CONTRACT CHANGE ORDER NO. 25
SHEET ___ OF ___

SAN FRANCISCO OAKLAND BAY BRIDGE
EAST SPAN SEISMIC SAFETY PROJECT

SEISMIC JOINT (HINGE A)

SHEET 448R4 OF

CROSS SECTION

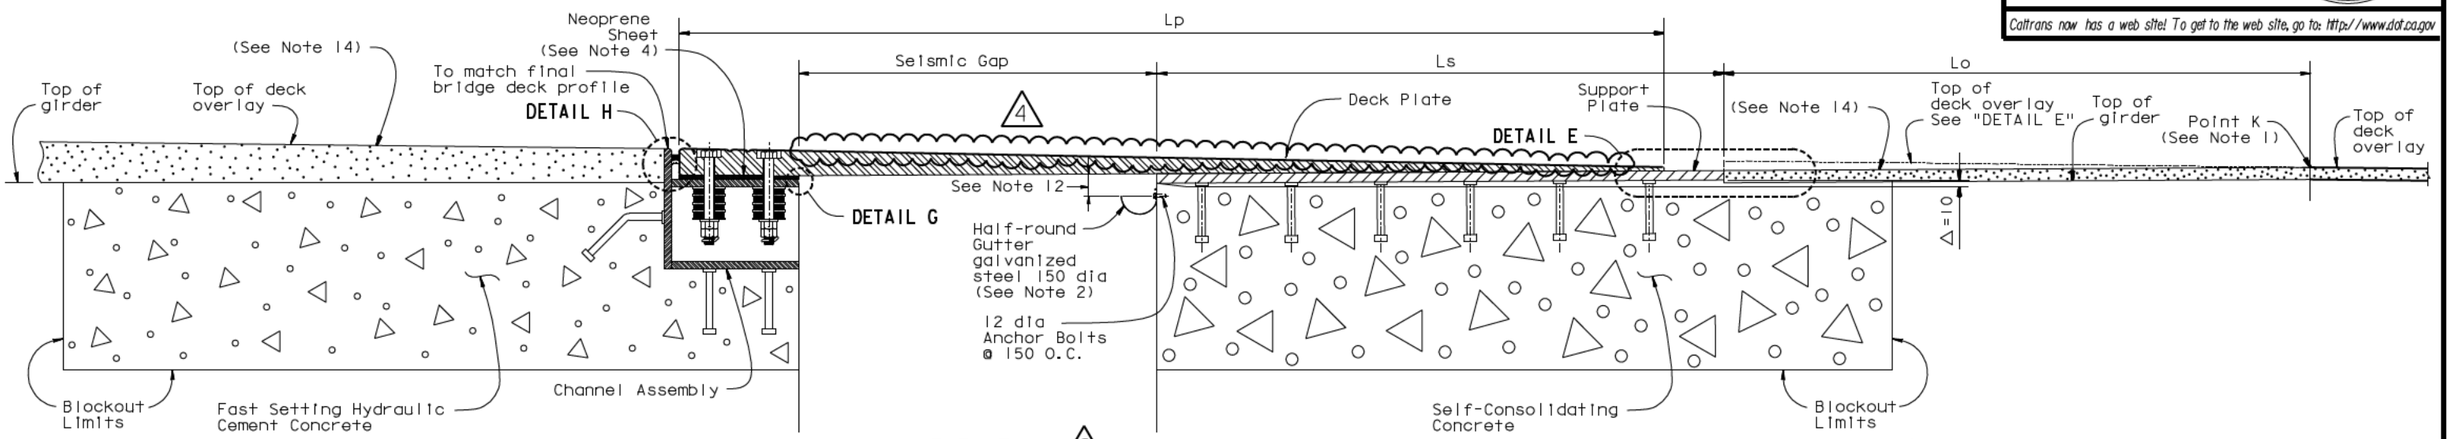
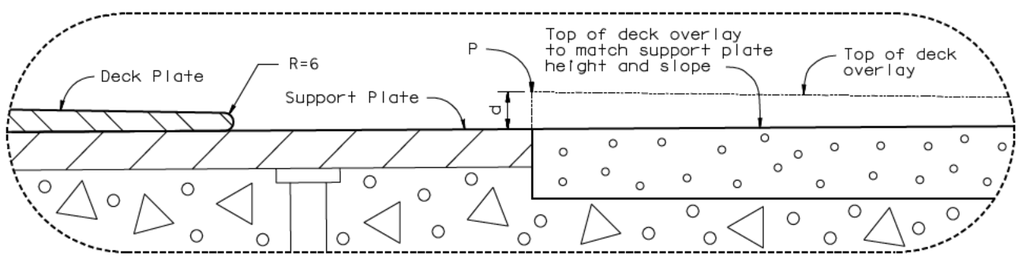
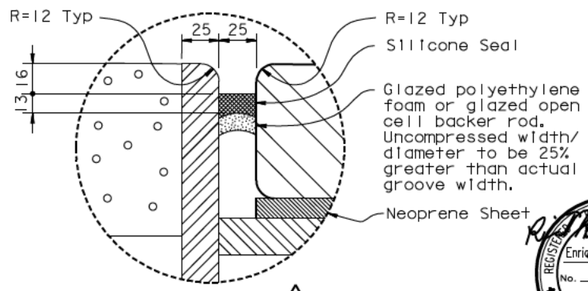
| MARK | DATE | DESCRIPTIONS | BY | CH'D | CCO # |
|---|---|---|---|---|---|
| 4 | 11/25/09 | Seismic Joint Modifications Hinge A | RM | AA | 25 |
| 3 | 7/17/08 | Seismic Joint Modifications Hinge A | TD | AK | 25 |
| 2 | 12/18/07 | Seismic Joint Modifications Hinge A | TD | AK | 25 |
